TSG-RAN Meeting #12
Stockholm, Sweden, 12-15, June, 2001

RP-010334

Title: Agreed CRs (R99 and Rel-4 Category A) to TS 25.214

Source: TSG-RAN WG1

Figure 6: Idle Period placement in the case of burst mode operation

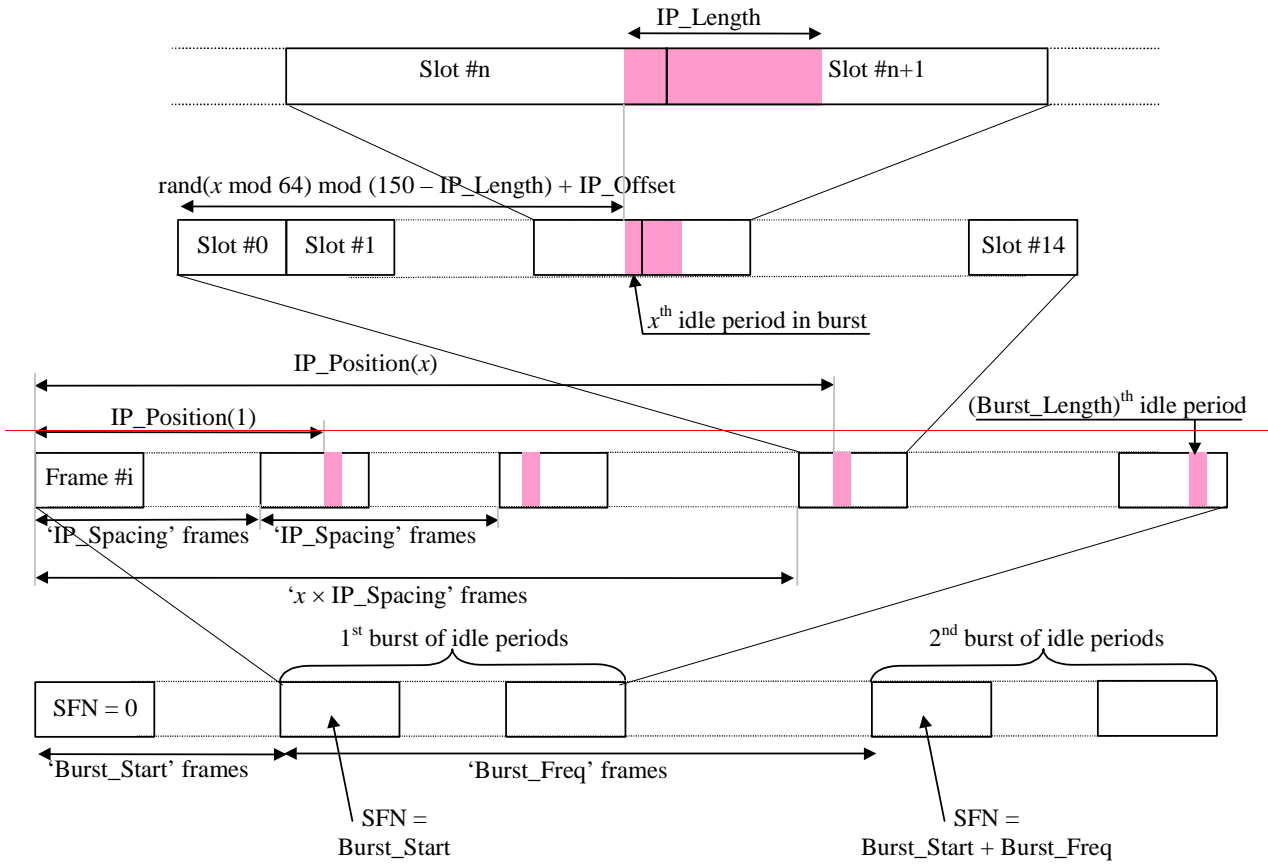
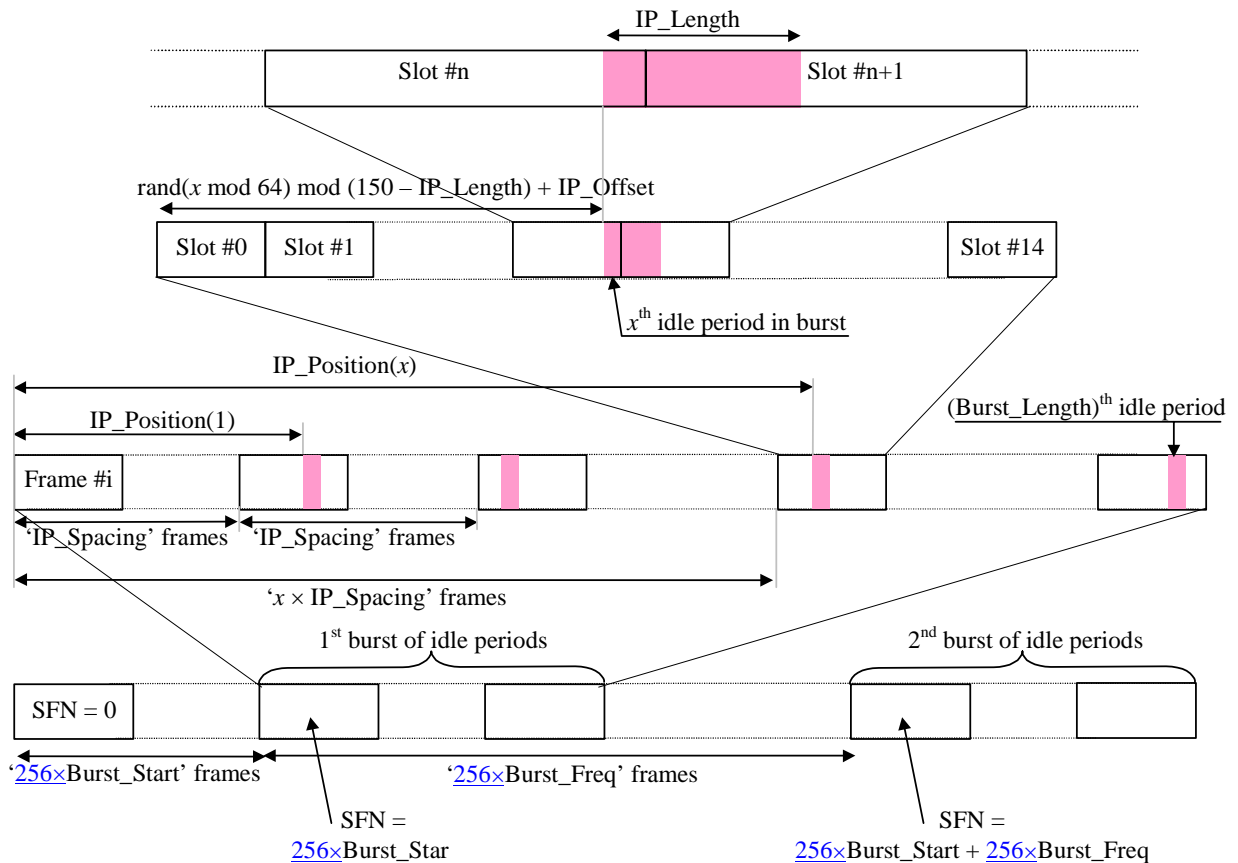
Reason for change:	⌘ In the current definition of some IPDL burst mode parameters the scaling factor of 256 is missing. This could lead to wrong starting points of the bursts in IPDL burst mode.
Summary of change:	⌘ Correction in the definition of the IPDL burst mode parameters.
Consequences if not approved:	⌘ Wrong calculation of starting points of IPDL bursts.

Burst_Start:	<u>Specifies the start of the first burst of idle periods. $256 \times \text{Burst_Start}$ is the SFN where the first burst of idle periods starts.</u>
Burst_Length:	The number of idle periods in a burst of idle periods.
Burst_Freq:	<u>Specifies the time between the start of a burst and the start of the next burst. $256 \times \text{Burst_Freq}$ is the number of radio frames of the primary CPICH between the start of a burst and the start of the next burst.</u>

In burst mode, the first burst starts in the radio frame with SFN = $256 \times \text{Burst_Start}$. The n :th burst starts in the radio frame with SFN = $256 \times \text{Burst_Start} + n \times 256 \times \text{Burst_Freq}$. The sequence of bursts according to this formula continues up to and including the radio frame with SFN = 4095. At the start of the radio frame with SFN = 0, the burst sequence is terminated (no idle periods are generated) and at SFN = $256 \times \text{Burst_Start}$ the burst sequence is restarted with the first burst followed by the second burst etc., as described above.

Figure 6: Idle Period placement in the case of burst mode operation

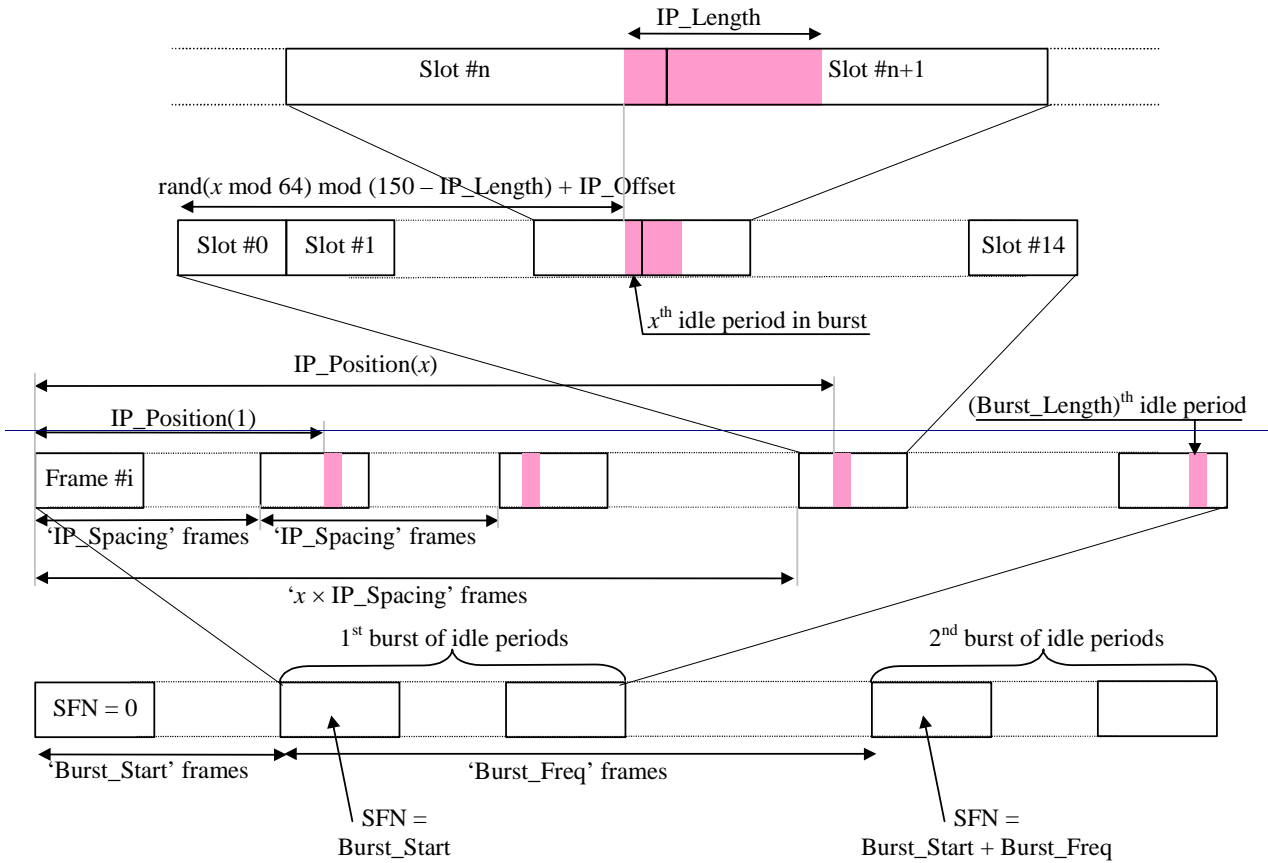
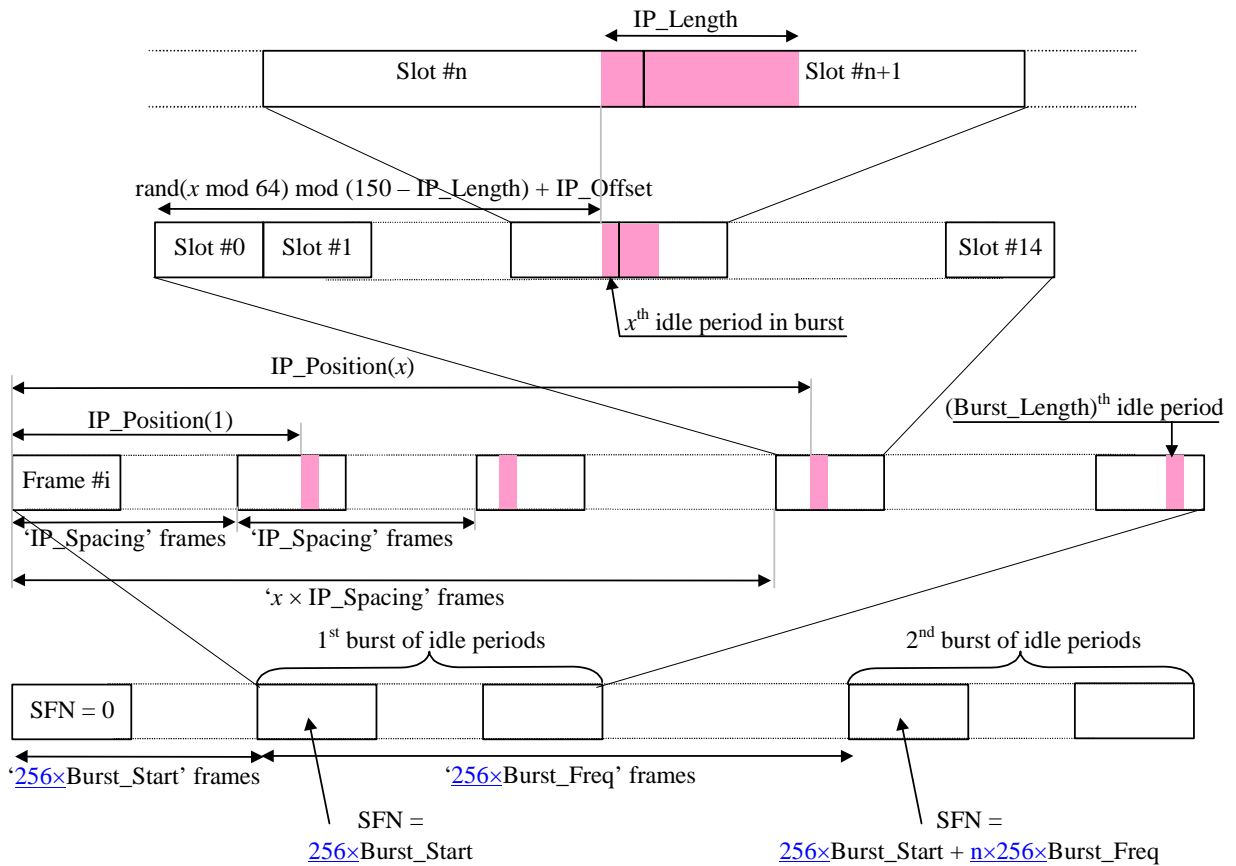
Reason for change:	⌘ In the current definition of some IPDL burst mode parameters the scaling factor of 256 is missing. This could lead to wrong starting points of the bursts in IPDL burst mode.
Summary of change:	⌘ Correction in the definition of the IPDL burst mode parameters.
Consequences if not approved:	⌘ Wrong calculation of starting points of IPDL bursts.
